✓ 2000-3 Arapaho Road  
Streetscape - 1999

DATE	5-24-99	JOB NO.
ATTENTION		
RE:	Arapaho Rd	
	Quorum Rd Tree Wells

COPIES	DATE	NO.	DESCRIPTION
3			Replacement Detail (A), Sheet LC-3 and Typ. Section through Tree Well

Arapaho Rd Revised Light  
Base Location

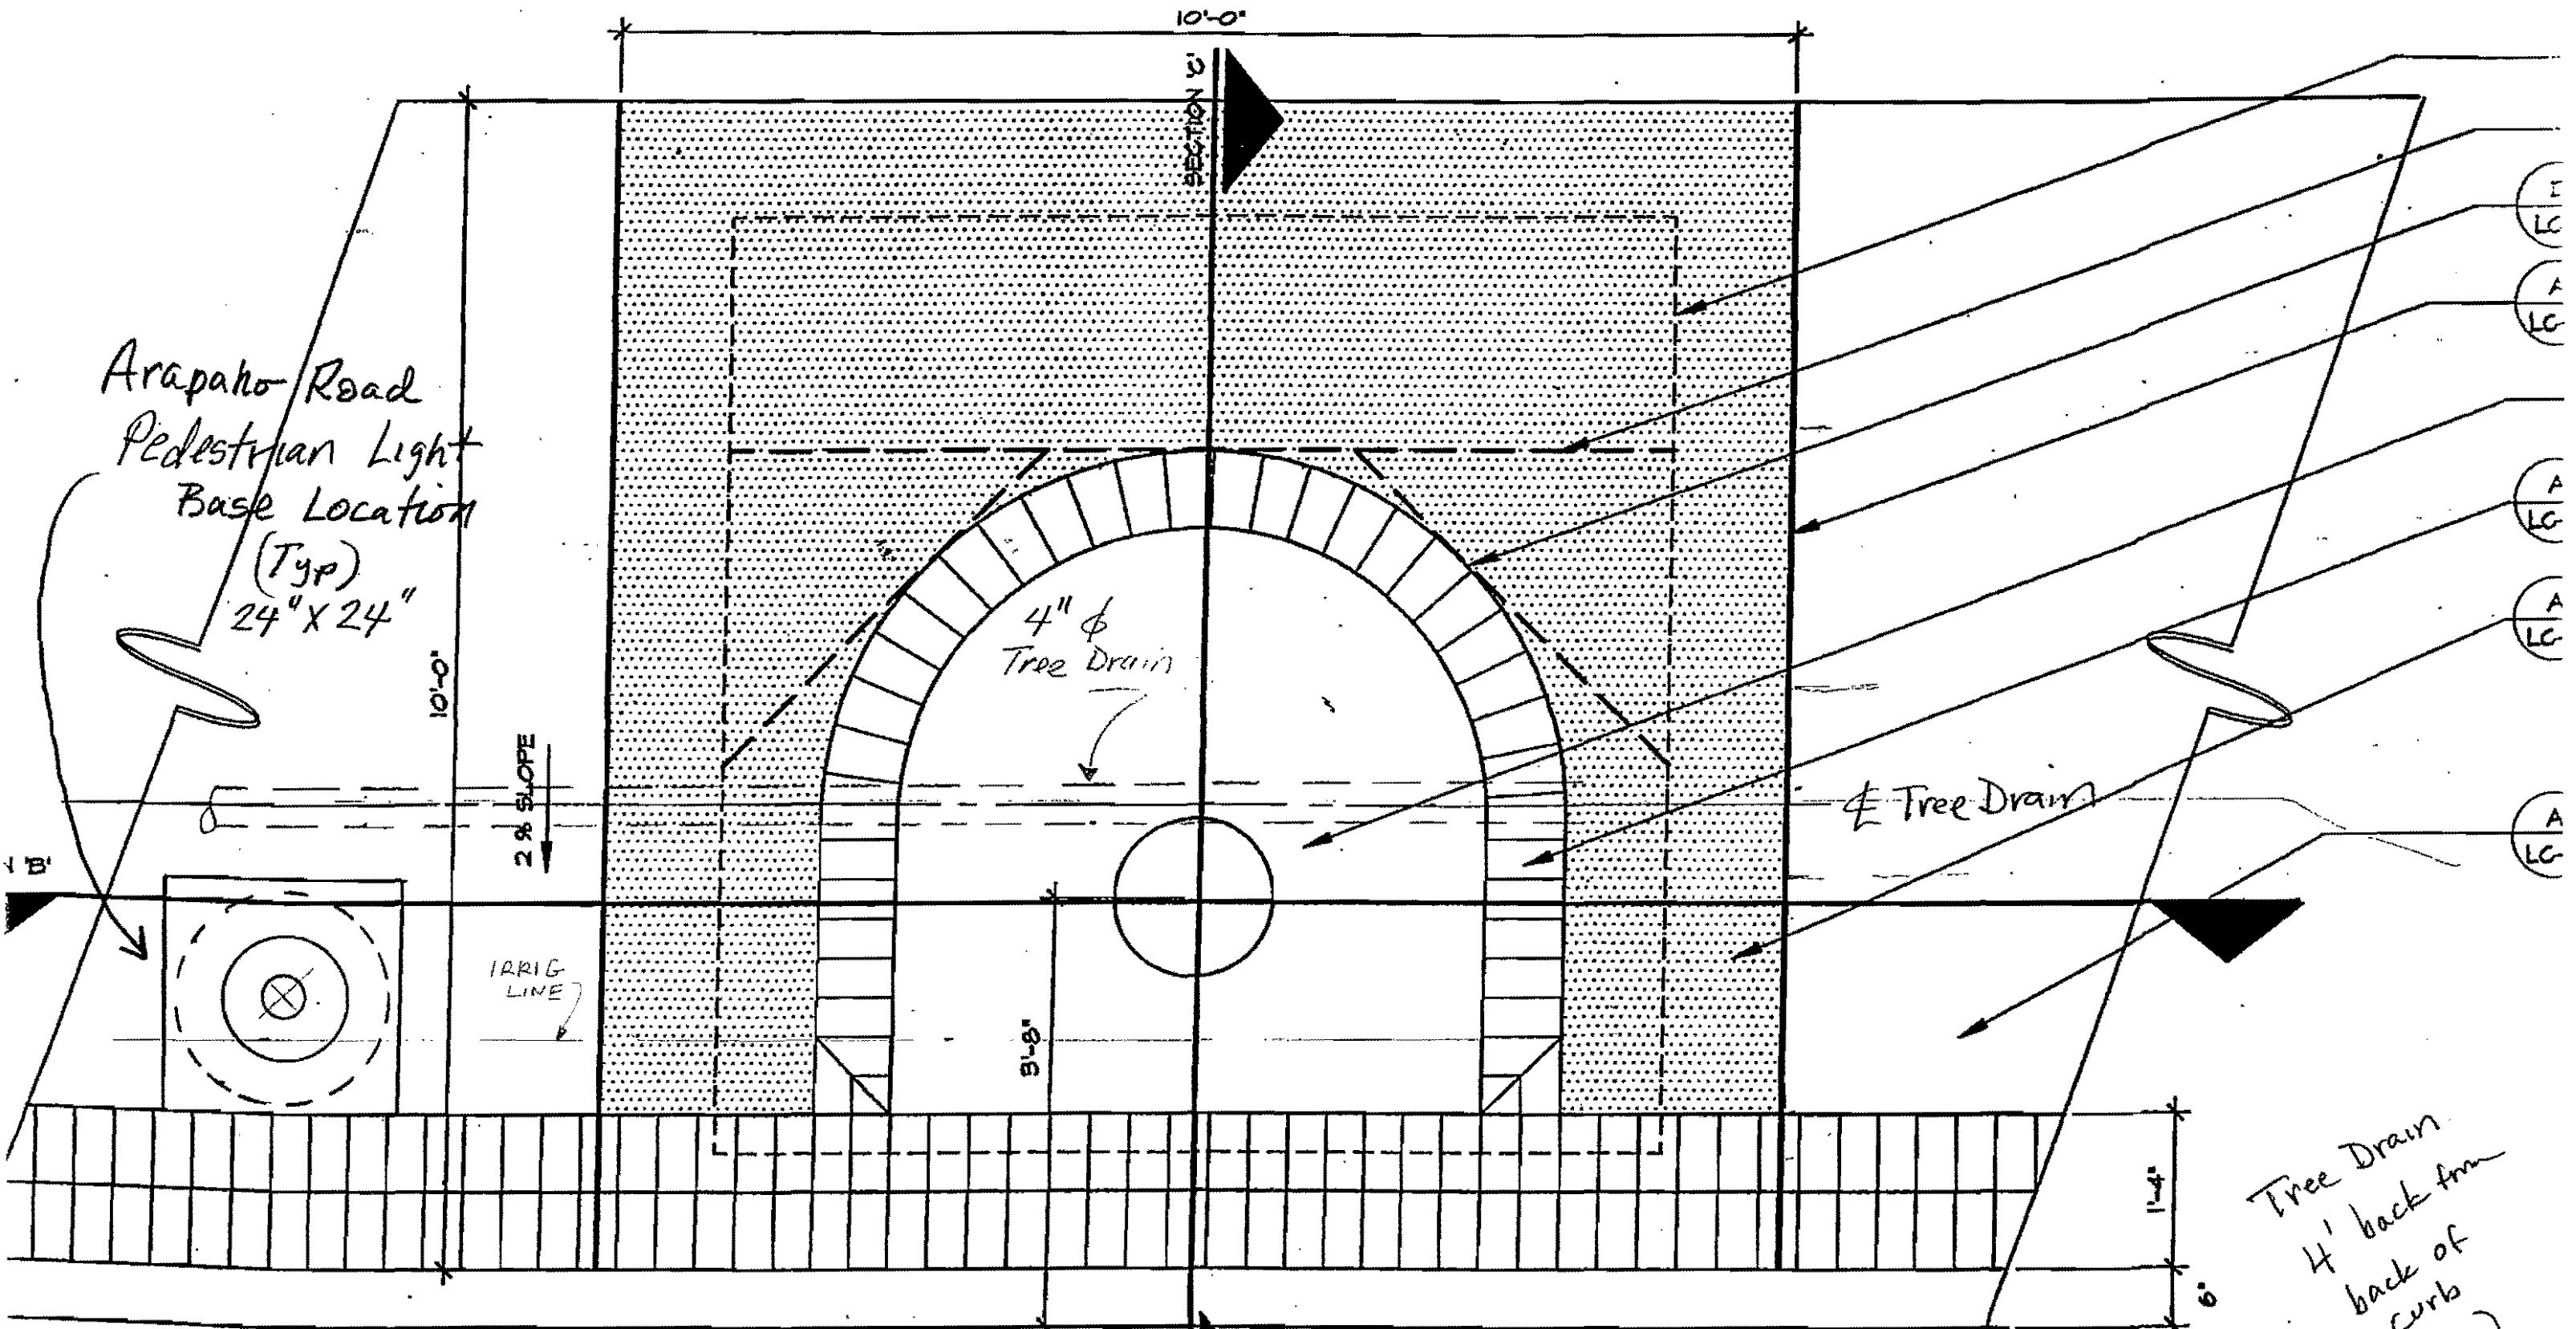
**REMARKS** This is to direct you to install tree well drains on Quorum Drive (both sides) north of Arapaho Rd. Tree well drains shall be connected to the flow line of the inlets and carried at curb grade for drainage into the inlets. Drains shall be 5'-6" back of back of curb as shown. Existing unit prices shall be used to pay for the work and quantities shall be increased accordingly. Pedestrian light-base locations shall be revised as shown (Arapaho Rd).

Note: Center Light Bases between  
Tree Walls as shown on plans
